Stage 03: Code Administration Consultation

Grid Code

GC0110: LFSM-O compliance requirements for Type As and B PGMs

Purpose of Modification: To update the Grid Code and G99 with revised text for limited frequency sensitive mode- over-frequency compliance so that manufacturers have clear pass/fail criteria for limited frequency sensitive mode-over-frequency compliance.

Figure 1 - +2.0Hz injection with 10% droop setting (initial response)

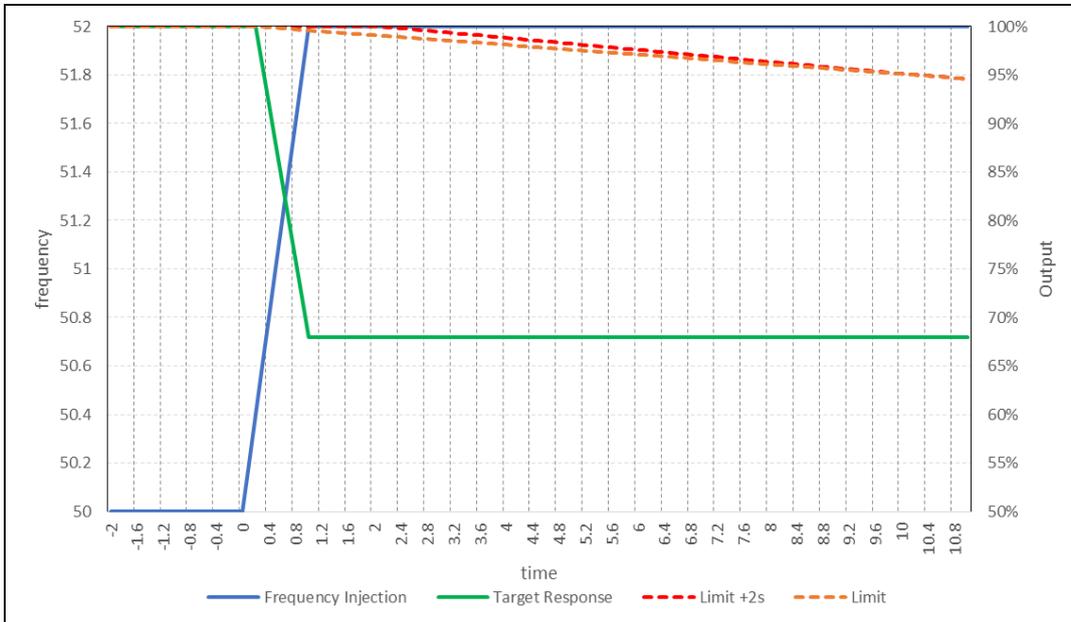
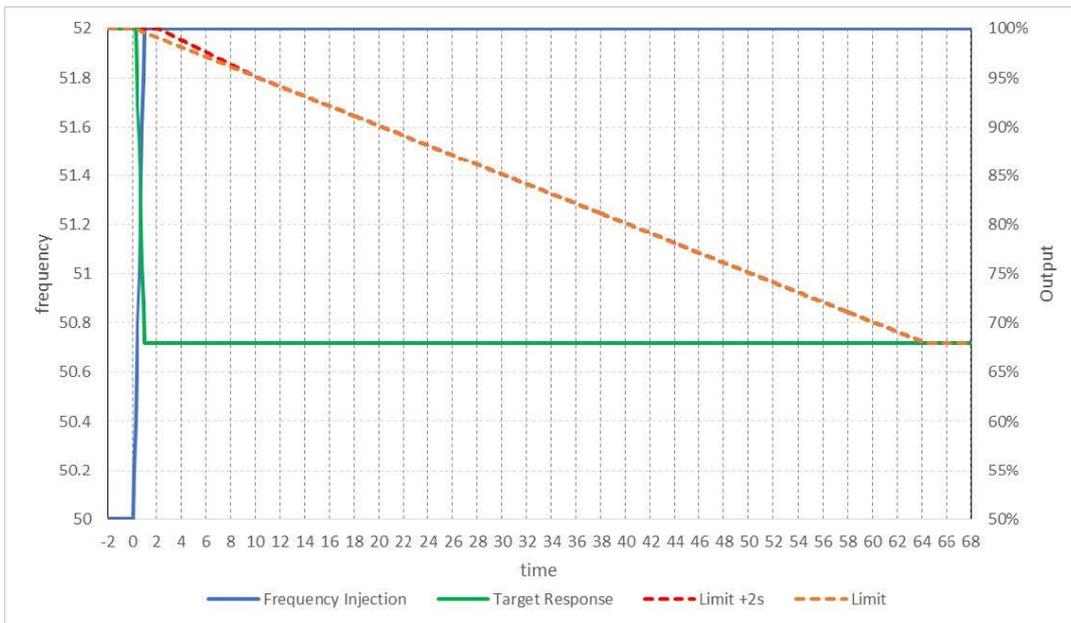
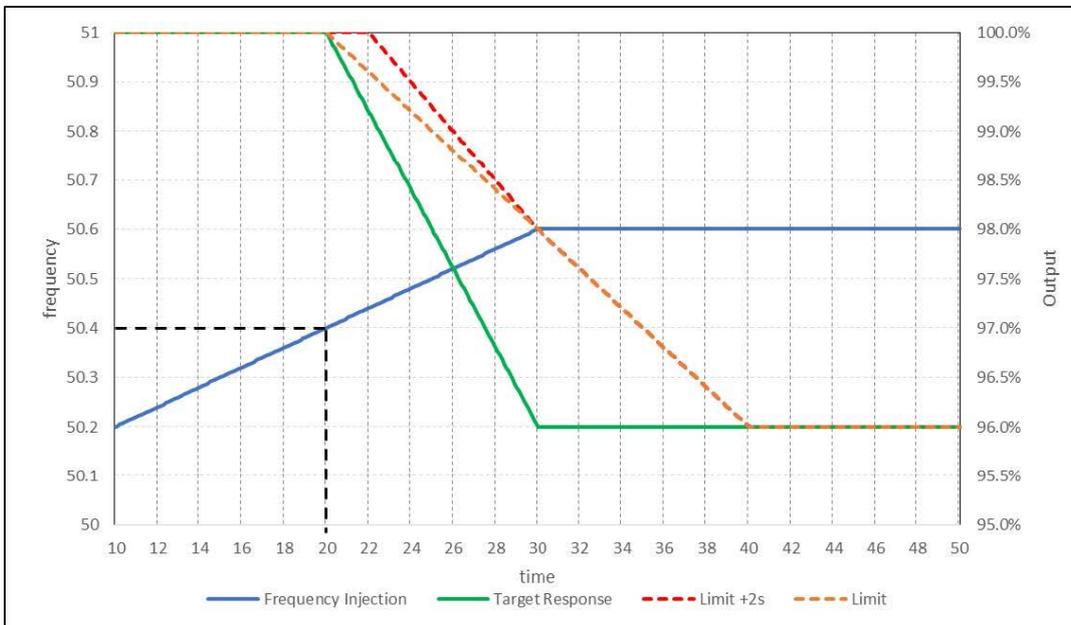
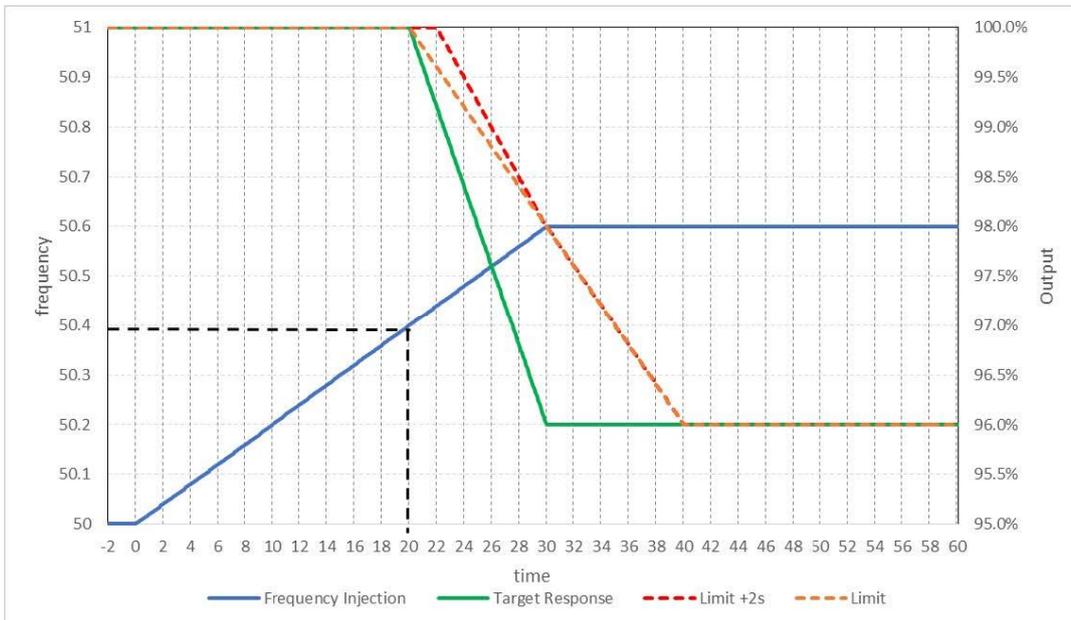
This is indicated graphically for an injection of a +2.0Hz step (as a 1 second ramp) in figures 1 & 2 and for an injection of a +0.6Hz ramp in figures 3 & 4. On the graphs the blue line indicates the injected frequency with the green line

showing the calculated minimum steady state response position in relation to the frequency deviation. The boundary of acceptable minimum response against time calculated in line with the methodology set out above is shown by the red dashed line. The difference between the orange and red lines indicates the permitted two second delay in for the initial measurable response but it is important to note that at the end of the time period (ie at 10 seconds) both the red and orange lines converge to the same point. For the avoidance of doubt any response which is on or below the red line is acceptable.

The Work group also discussed with the permitted 2 second delay in starting to respond to a frequency change should be allowed to apply after the 10 second activation period and hence change the red lines in figures 1,2,3 and 4 to be parallel to the orange line and not coincide after 10 second. After discussion it was agreed the current interpretation with the lines coinciding after 20 seconds as per the proposal is acceptable.

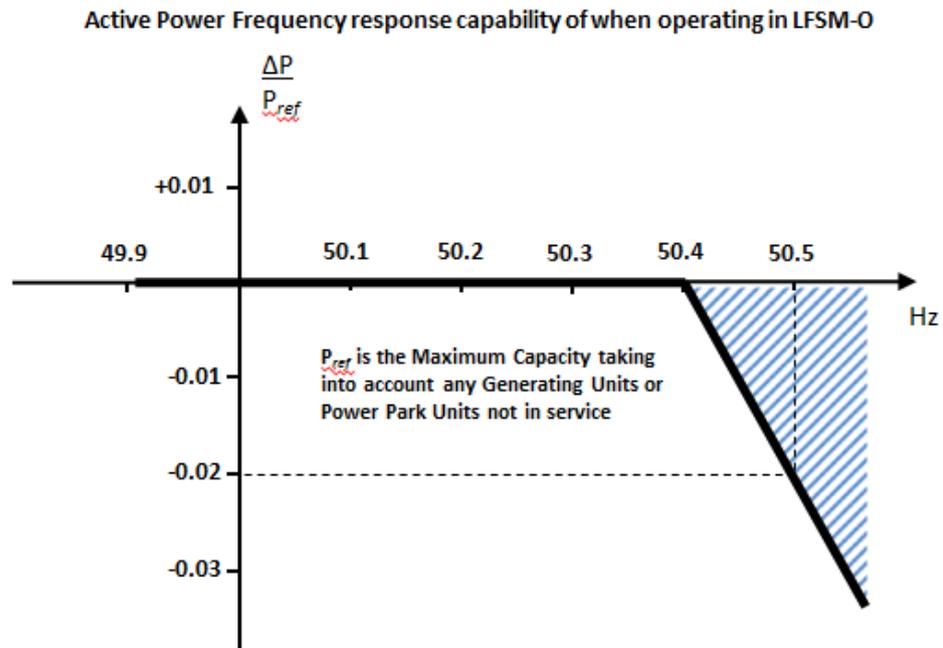
- ECC.6.3.7.1.2
- (i) The rate of change of **Active Power** output must be at a minimum a rate of 2 percent of output per 0.1 Hz deviation of **System Frequency** above 50.4Hz (ie a **Droop** of 10%) as shown in Figure ECC.6.3.7.1 below. This would not preclude a **EU Generator** or **HVDC System Owner** from designing their **Power Generating Module** with a **Droop** of less than 10% but in all cases the **Droop** should be 2% or greater.

- (iii) As much as possible of the proportional reduction in **Active Power** output must result from the frequency control device (or speed governor) action and must be achieved within 10 seconds of the time of the **Frequency** increase above 50.4 Hz. The **Power Generating Module** (including **DC Connected Power Park Modules**) or **HVDC Systems** shall be capable of initiating a power **Frequency** response with an initial delay that is as short as possible. If the delay exceeds 2 seconds the **EU Generator** or **HVDC System Owner** shall justify the ~~delay~~variation, providing technical evidence to **NGET**.

- (v) For the avoidance of doubt, the **LFSM-O** response must be reduced when the **Frequency** falls again and, when to a value less than 50.4Hz, as much as possible of the increase in **Active Power** must be achieved within 10 seconds.

- (iv)(vi) For **Type A** and **Type B Power Generating Modules** which are not required to have **Frequency Sensitive Mode (FSM)** as described in ECC.6.3.7.3 for deviations in **Frequency** up to 50.9Hz at least half of the proportional reduction in **Active Power** output must be achieved in 10 seconds of the time of the **Frequency** increase above 50.4 Hz. For deviations in **Frequency** beyond

50.9Hz the measured rate of change of **Active Power** reduction must exceed 0.5%/sec of the initial output. The **LFSM-O** response must be reduced when the **Frequency** subsequently falls again and, when to a value less than 50.4Hz, at least half the increase in **Active Power** must be achieved in 10 seconds. For a **Frequency** excursion returning from beyond 50.9Hz the measured rate of change of **Active Power** increase must exceed 0.5%/second.

Figure 1 - +2.0Hz injection with 10% droop setting (initial response)

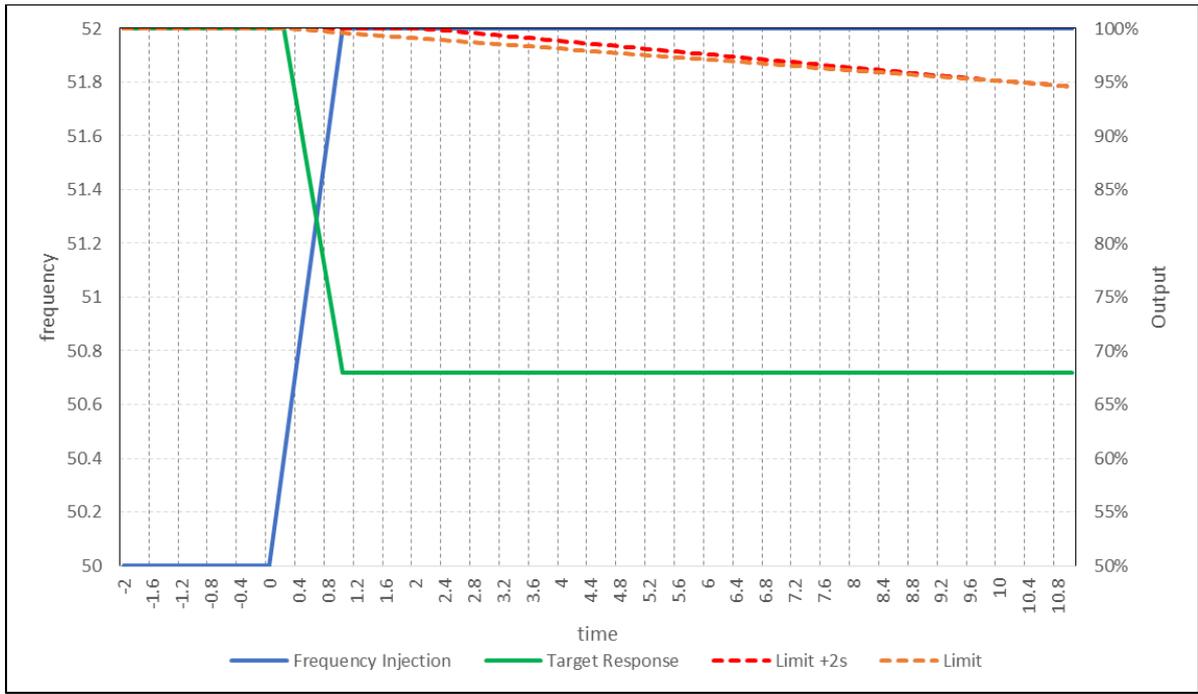
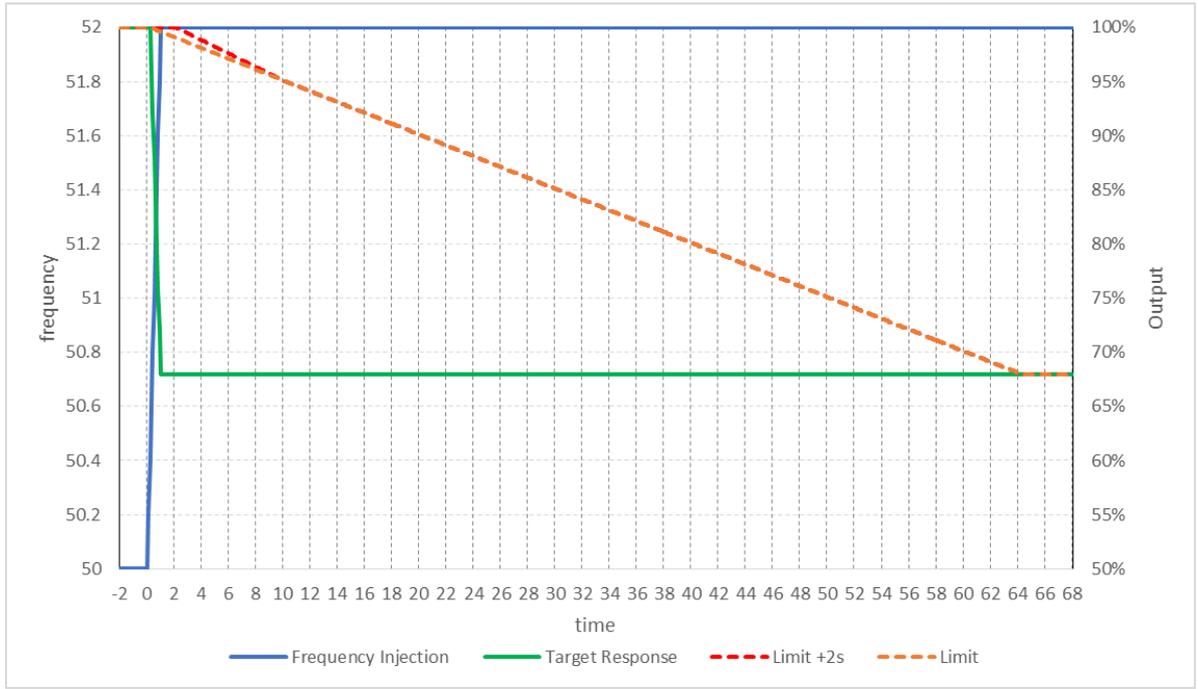
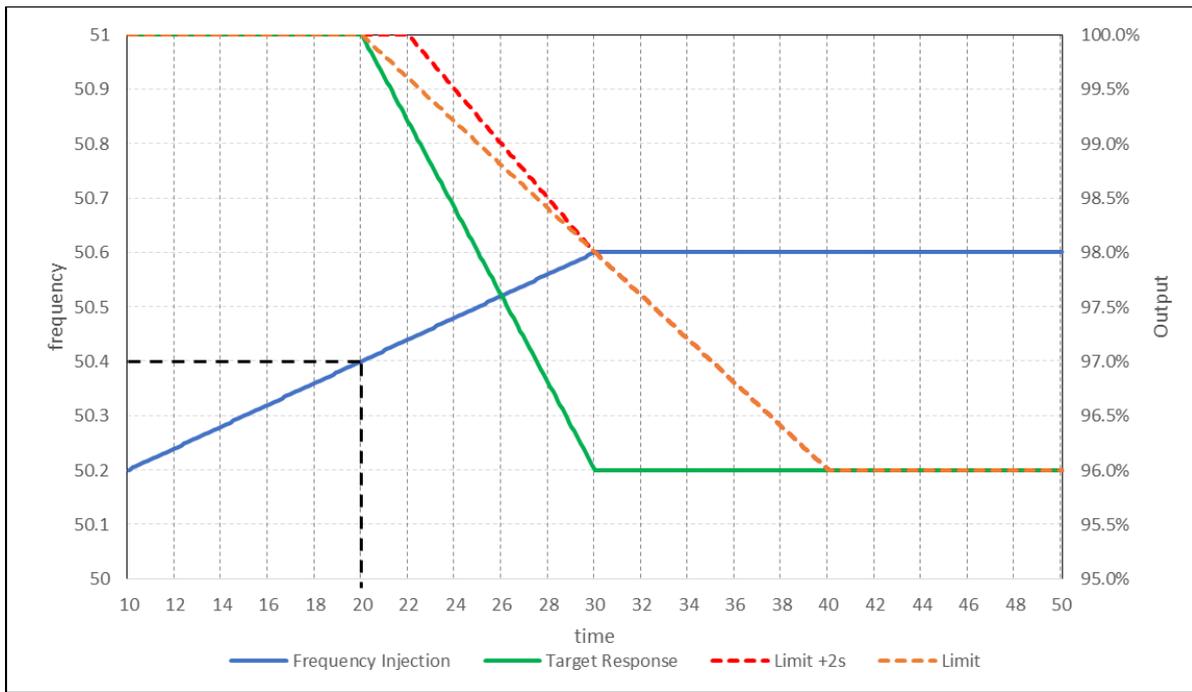
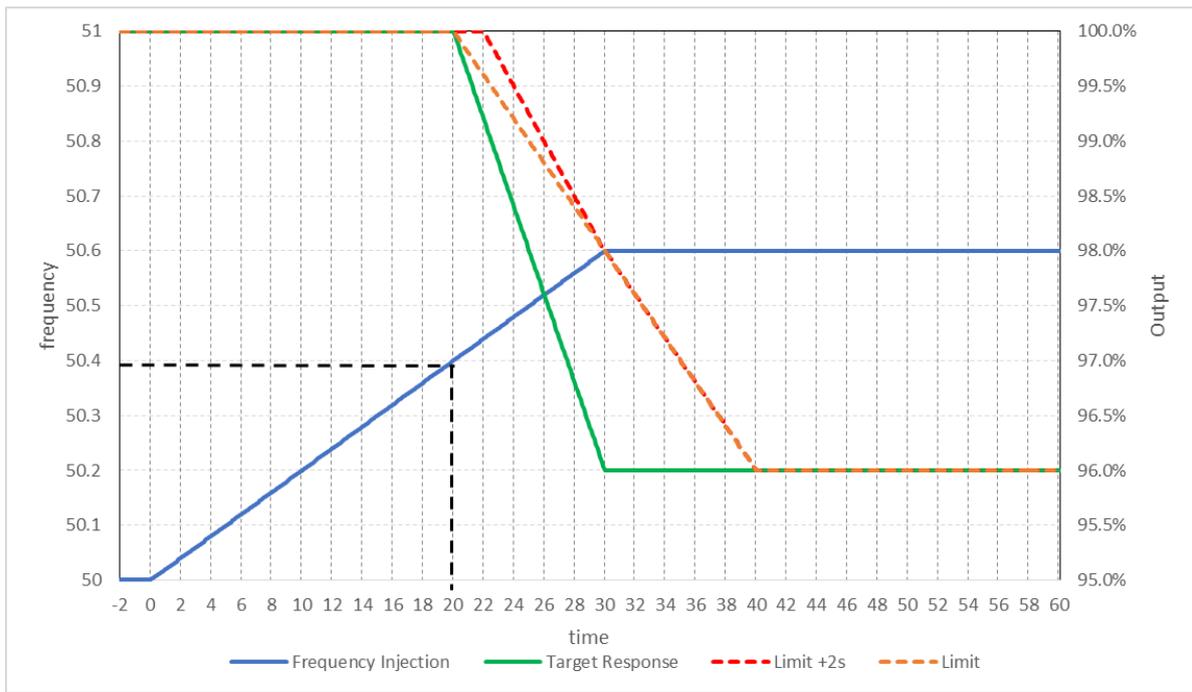
This is indicated graphically for the +2.0Hz step and +0.6Hz ramp injections in the following figures with the green lines indicating the calculated response position in relation to the frequency deviation The red dashed line indicates the boundary of acceptable response in line with the interpretation set out above. The difference between the orange and red lines indicates the permitted two second delay in for the initial measureable response but it is important to note that at the end of the time period (ie at 10seconds) both the red and brown lines converge to the same point..

LFSM-O BC4 test – Application of minimum response dynamic

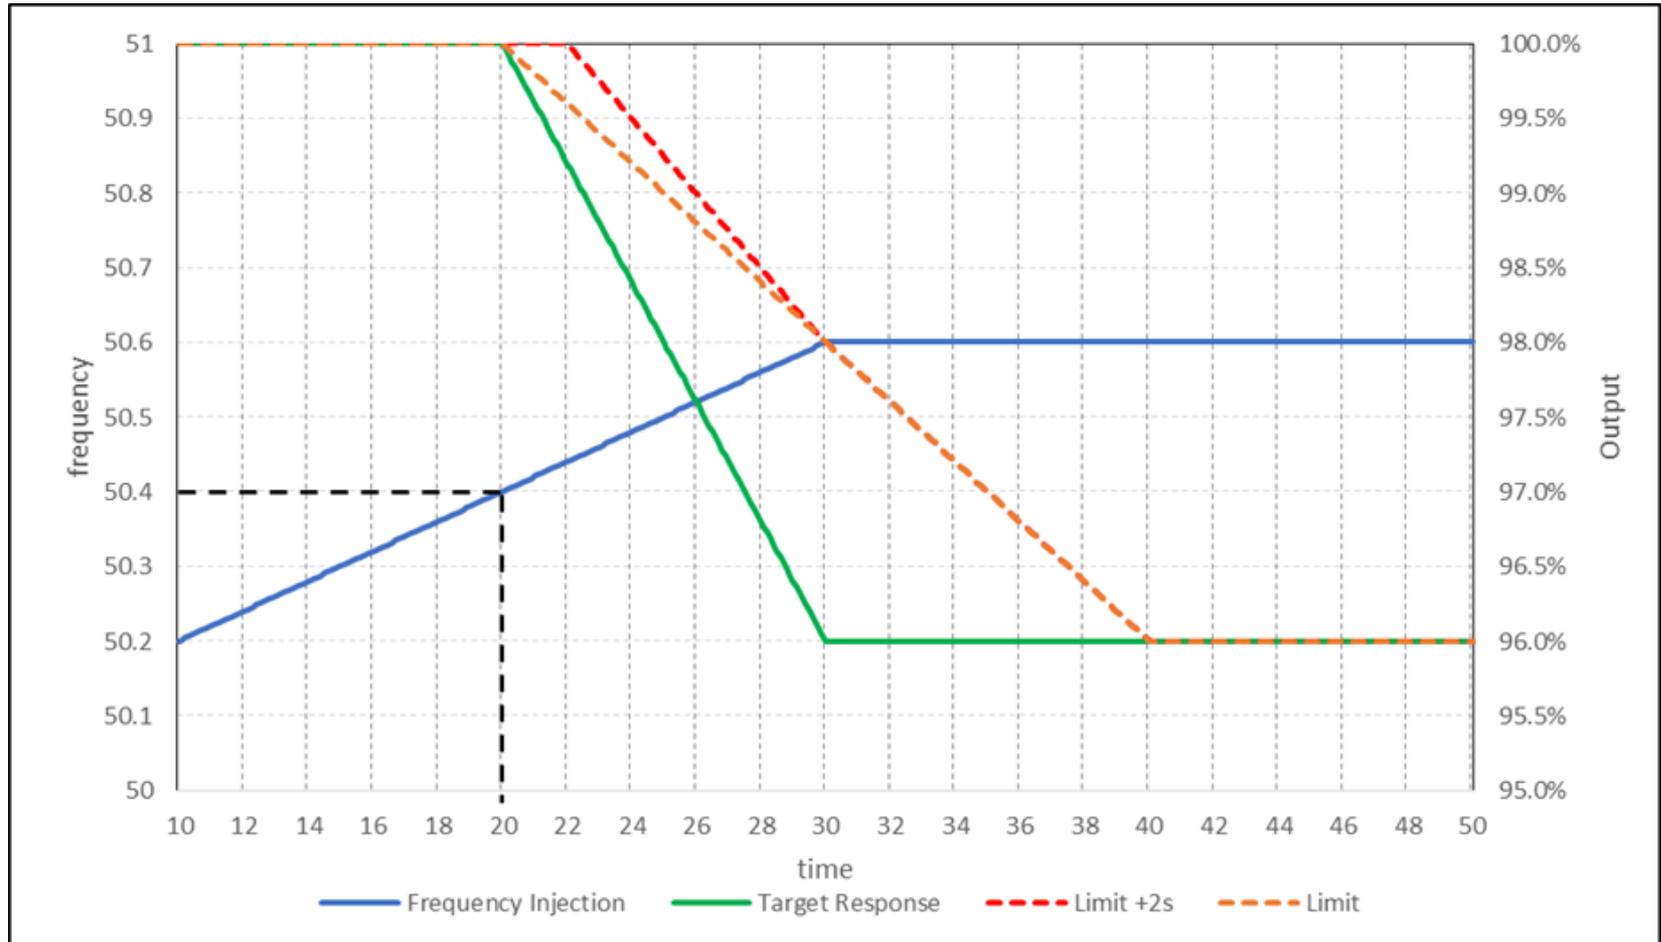
- What is the limit of compliance for LFSM-O?
- Recognised for Type B, a product spec is the best approach. This needs a clear position for compliance to test against.
- RfG offers no clue on acceptable timing for delivery of the droop response, but a dynamic requirement is necessary to satisfy the droop.
- Grid Code text still does not give a clear position for compliance. Generally not an issue for larger plant (Type C/D) with FSM capability.
- Discussion note developed with ENA which sets backstop position of 50% of response capped at 5% in 10 seconds.

- Limit of compliance for LFSM-O test BC3 compared to Typical

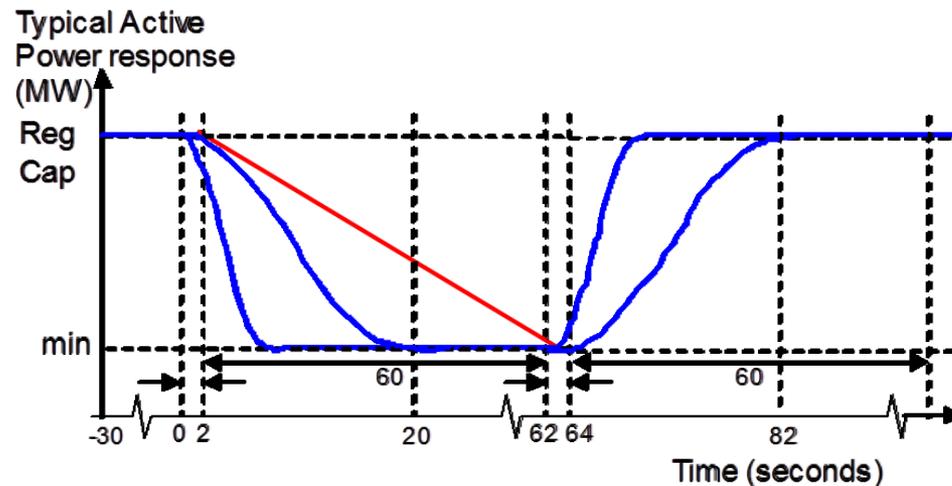
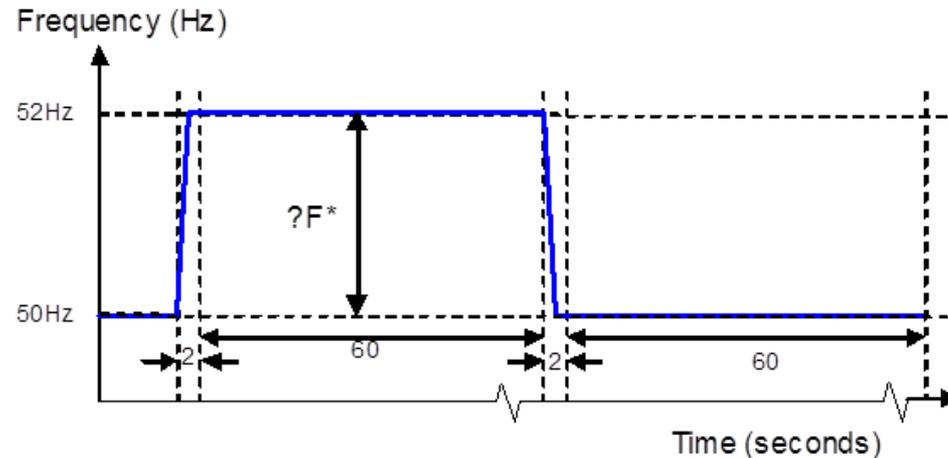
LFSM-O Backstop Compliance Position
